COMMITTEE OF ADJUSTMENT REPORT SUMMARY MINOR VARIANCE APPLICATION A237/21

| AGENDA ITEM NUMBER: 10 | CITY WARD 1 |
|---|---|
| PROPERTY: | 95 Northern Pines Blvd Kleinburg |
| PURPOSE OF APPLICATION: | Relief from the City's Zoning By-law is being requested to permit the construction of a proposed cabana to be located in the rear yard. |

CABANA

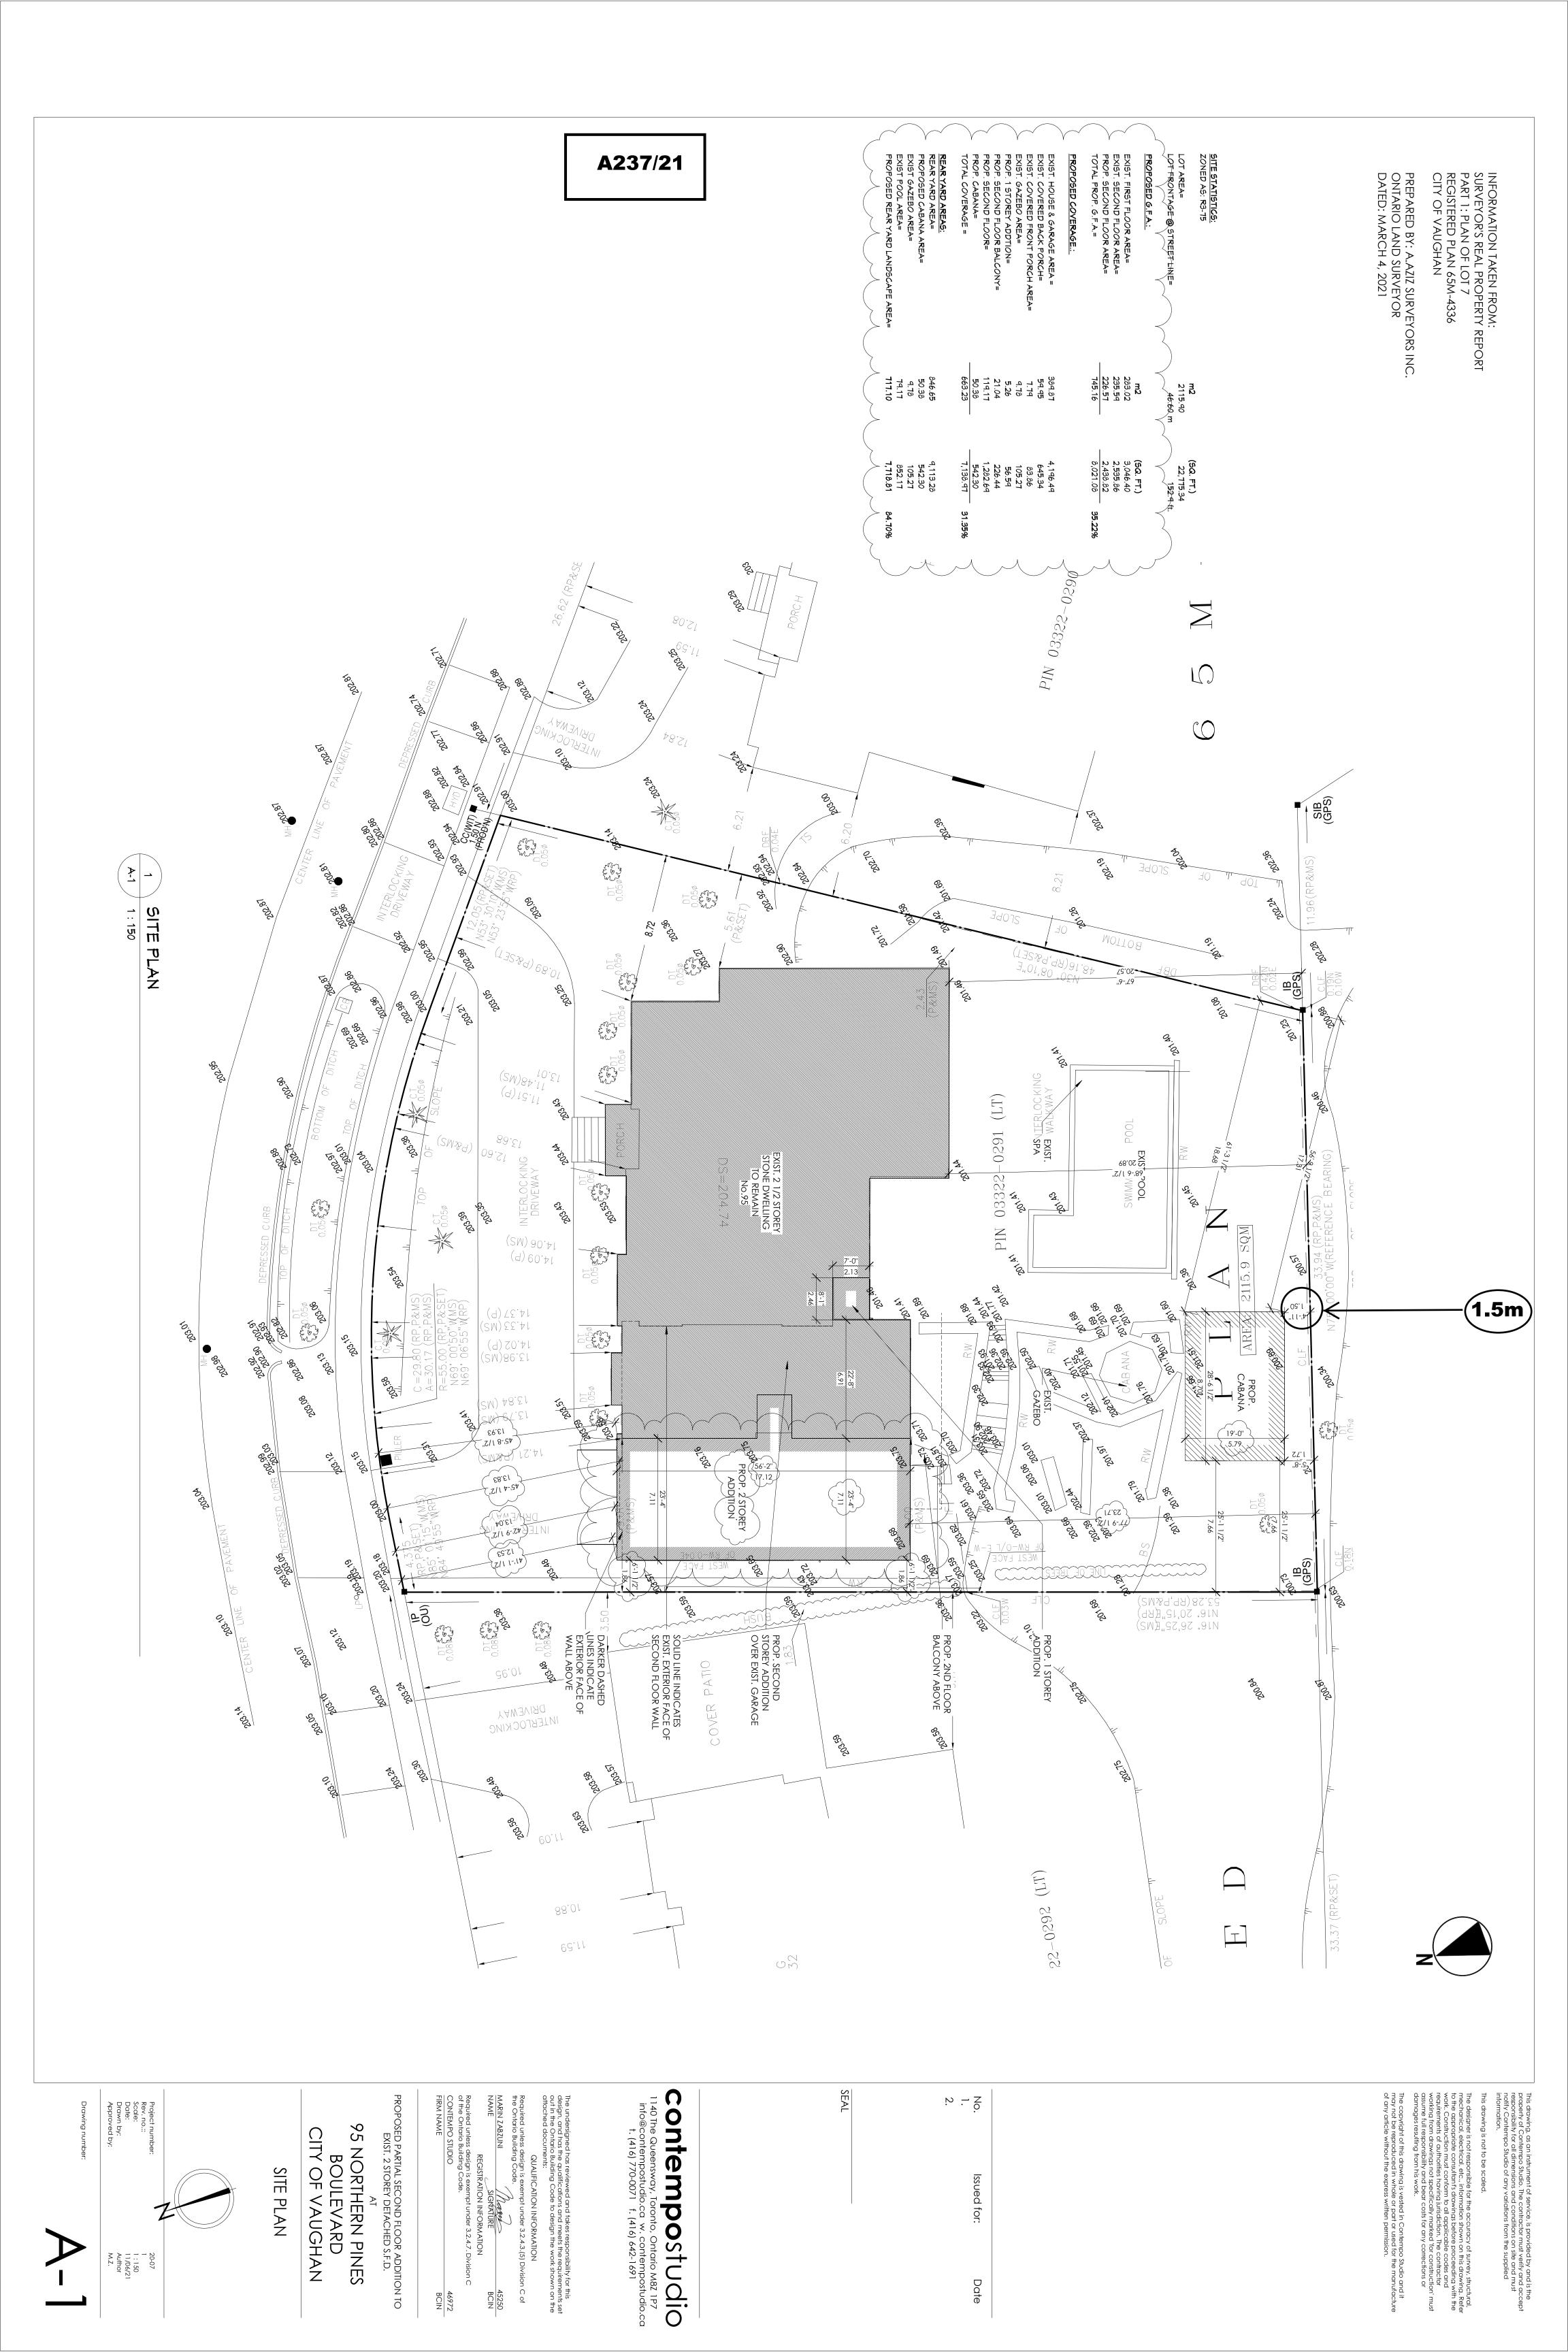
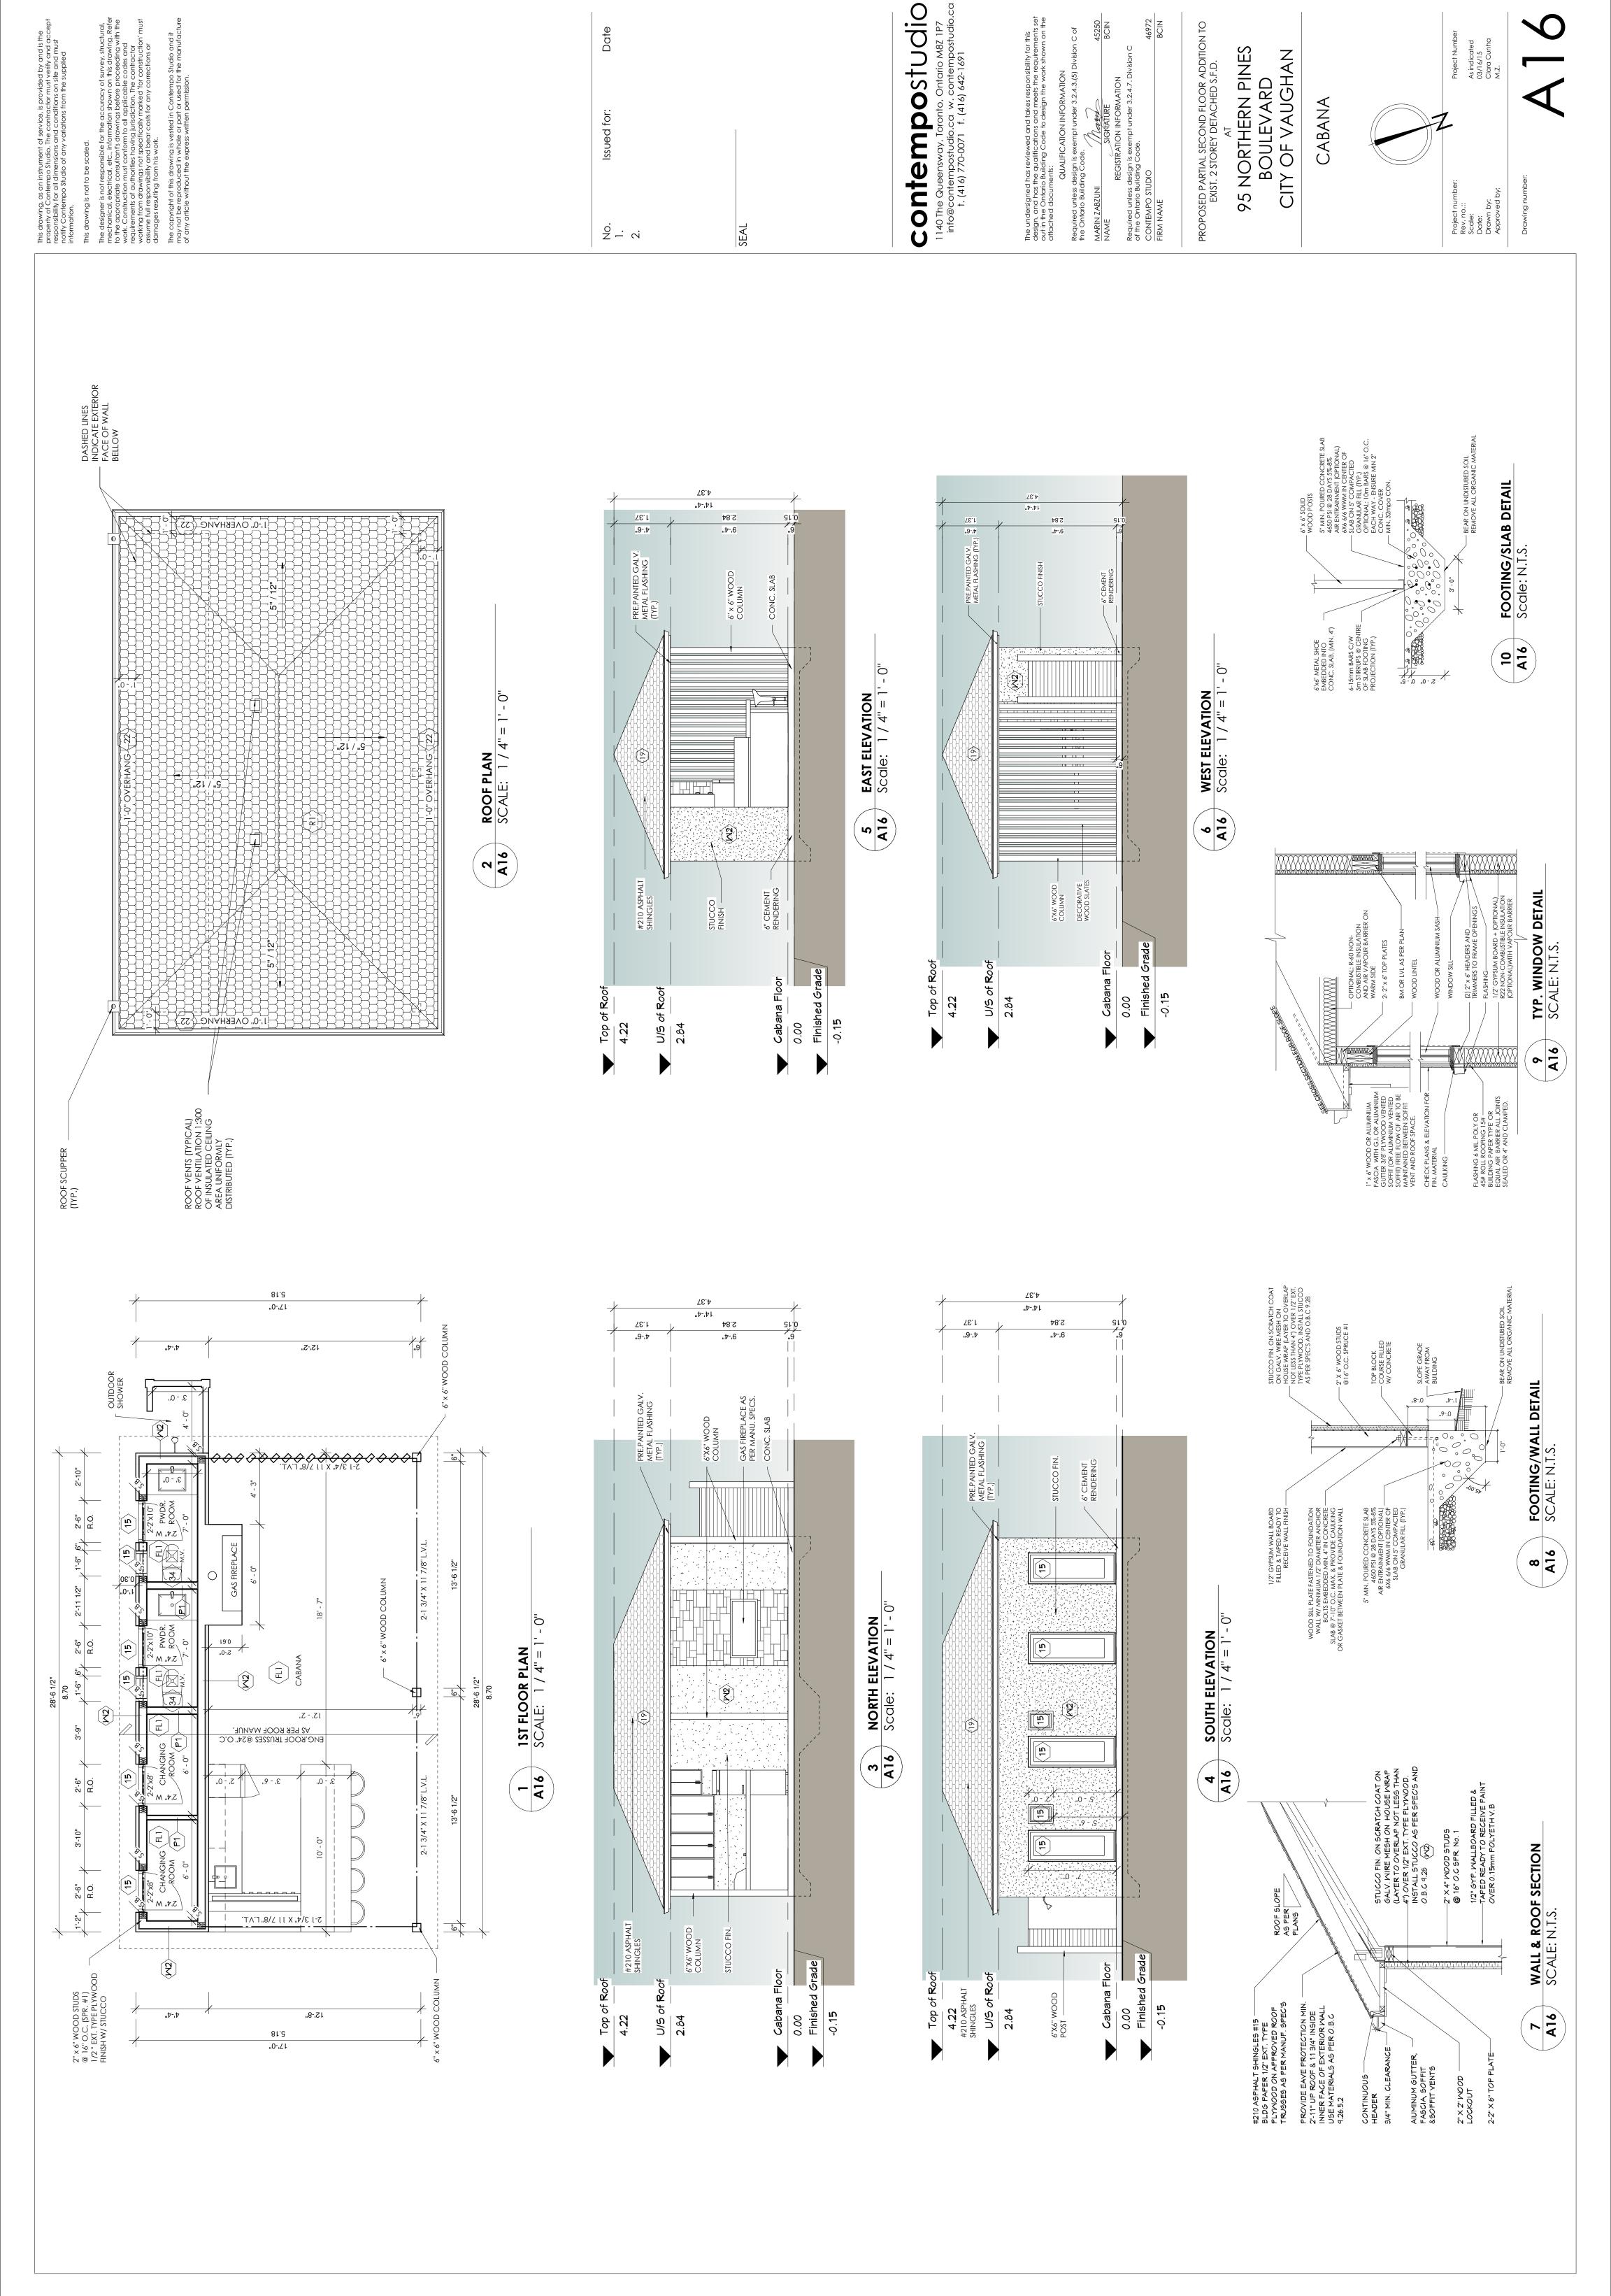
The Development Planning Department has no objections to the requested variance. The proposed cabana meets the height and area requirements of the Zoning By-law, and the rear of the property abuts a large open space, thereby the potential impacts of the proposed reduction in rear yard setback is minimal.

The Development Planning Department recommends approval of the application.
